To: T10 Technical Committee  
 From: Mahbubul Bari ([bari@vitesse.com](mailto:bari@vitesse.com))  
 Subject: SAS-2 Return Loss Measurement Methodology

Figure xyx Receiver Differential and Common Mode Return Loss

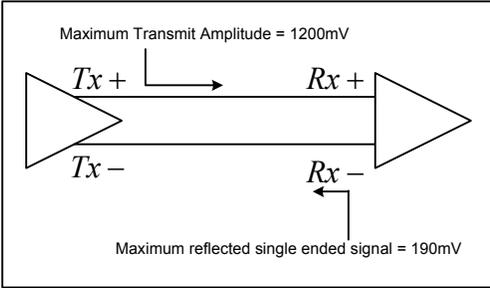
Maximum Transmit amplitude is 1200mV.  
Receiver return loss specified at -10dB.  
Network Analyzer Amplitude should be limited to 190mV.

Figure B.13 — Four single-ended port or two differential port element

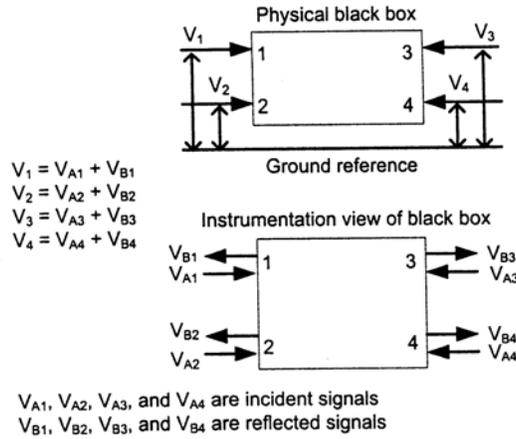
3) SAS2r08 - Section B.9 in Annex B describes S-parameter measurements. Clarification should be added to section B.9.3 on transmitter and receiver connection related to the S-parameter measurements. Will also include the derivation information.

VNA ports are all single-ended; the differential and common-mode properties for differential ports are calculated internal to the VNA or may mathematically derived. If using a TDNA, consult the details for the specific instrument. Four analyzer ports are required to measure the properties of two differential ports.

Figure B.14 — S-parameters for single-ended and differential systems

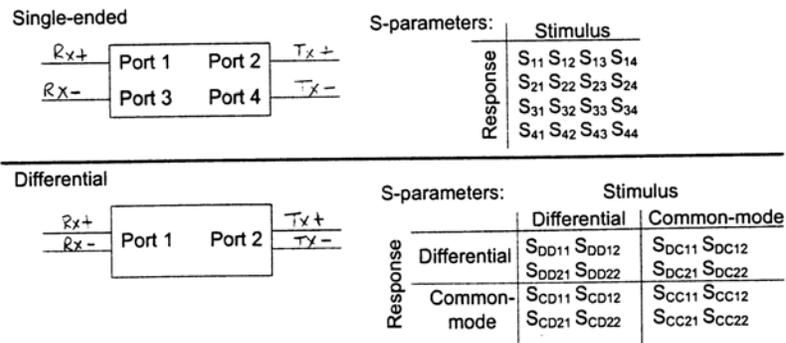
Figure B.14 shows the set of S-parameters for a single-ended system and for a differential system.
